January 13, 2020

REVISED: November 28, 2022

Re: Peer Review #3 - Reply

Proposed 16-Lot Definitive Subdivision Plan
Applicant/Developer: Robert Roderiques
Site Address: Hiller Avenue & Timothy Street
Assessors Lots #71 and #71A on Map #28C

PLAN 1A

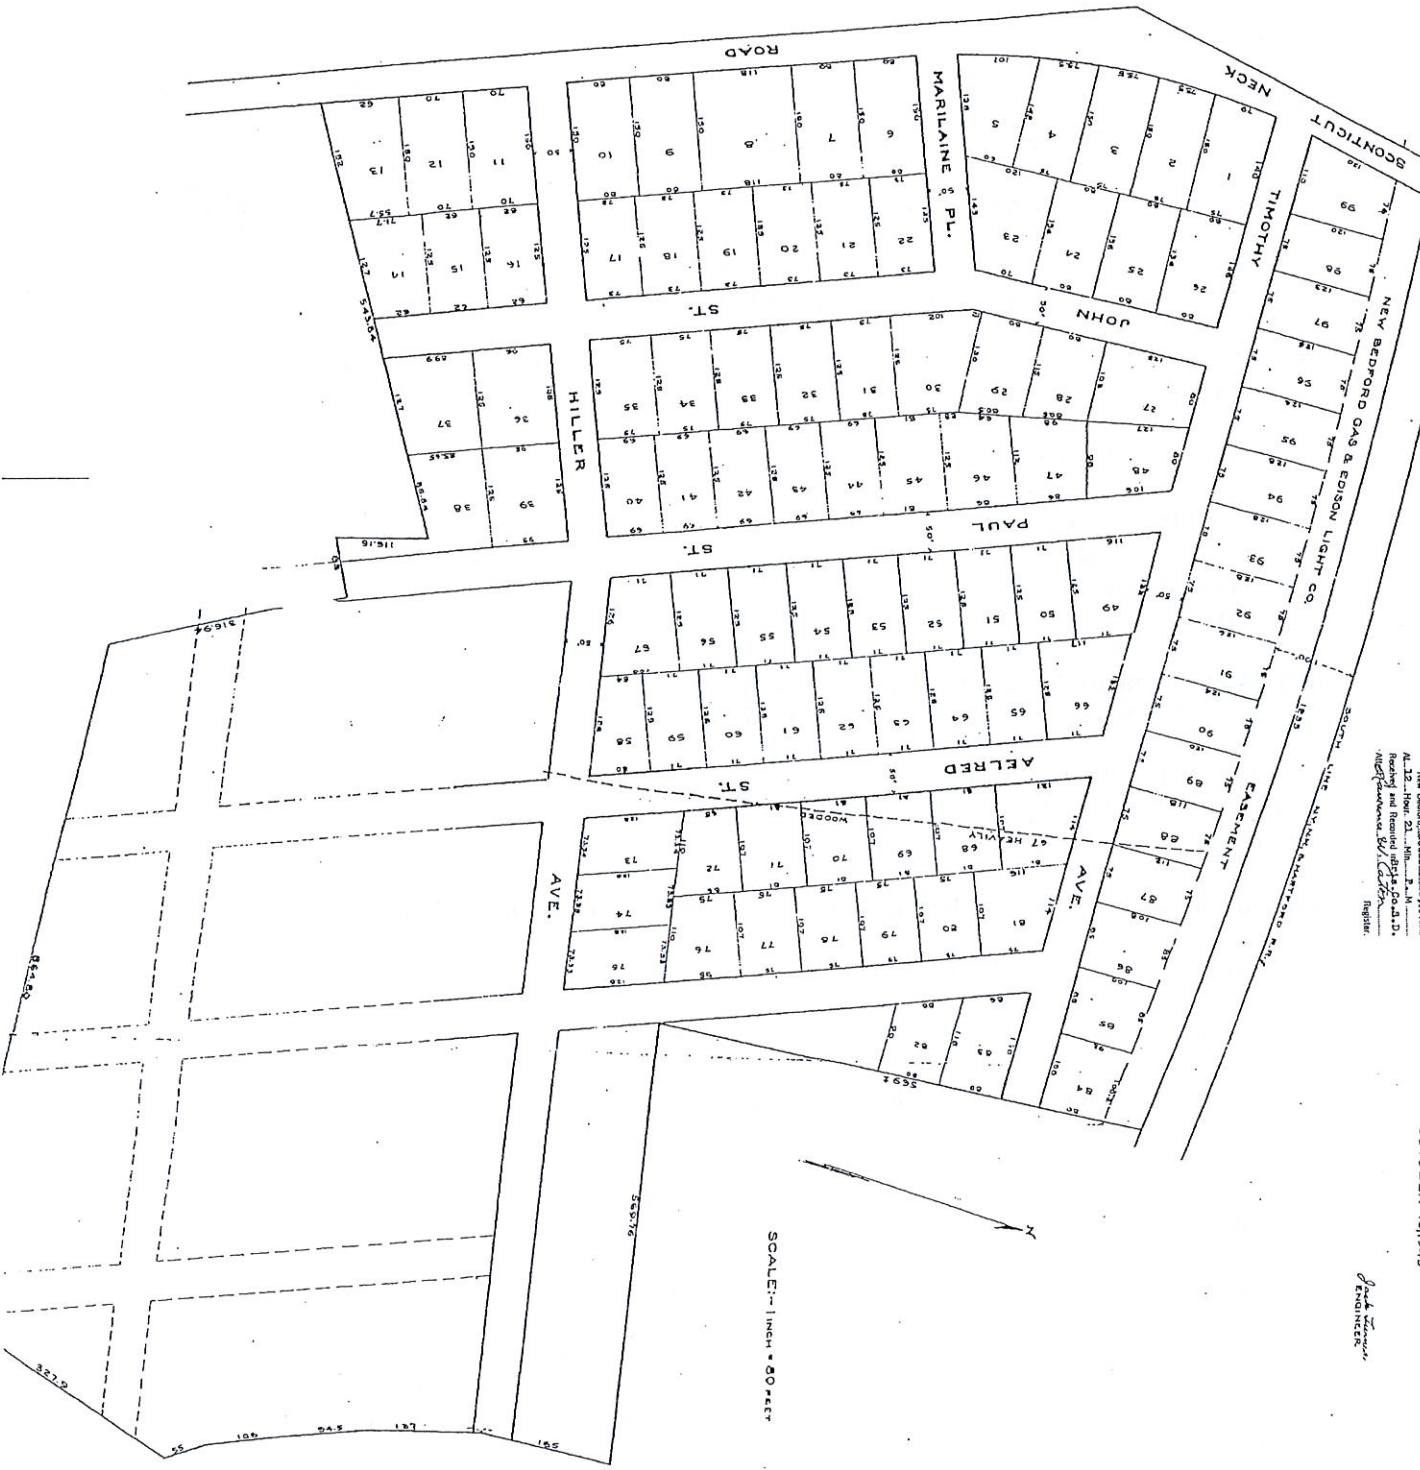
1. ***Resolved***
2. ***No Reply Required***
3. 322-14(C)(19) – Existing utility pole and overhead wires should be shown on the plan, Existing water and sewer main size and material should be shown upstream and downstream manholes and invert(s) should be provided to determine flow direction and capacity. ***The existing utility poles closest to the two proposed roadways and their respective overhead wires have been added to the plans. The existing water main types and sizes and the sewer main sizes, slopes and directions have been shown. However please note that the type of the sewer pipe located in Hiller Avenue is unknown to the Sewer Dept. The applicant should provide all necessary data to assist the Board to determine the existing surrounding municipal infrastructure is sufficient and/or capable of handling the additional volume. (322-18 C.) All available information has been provided. The applicant should identify the existing sewer pipe material and conditions in Hiller Avenue. The pipe is approximately 165' in length and services no more than two dwellings. This is a multimillion-dollar development connecting to an unknown pipe. The applicant should investigate the conditions and capacity of the existing sewer main.***

It should be noted that the reason sewer and water mains exist at the bottom of Hiller Avenue where no houses exist is because both mains were originally installed circa 1946 to accommodate extensive future development (see attached).
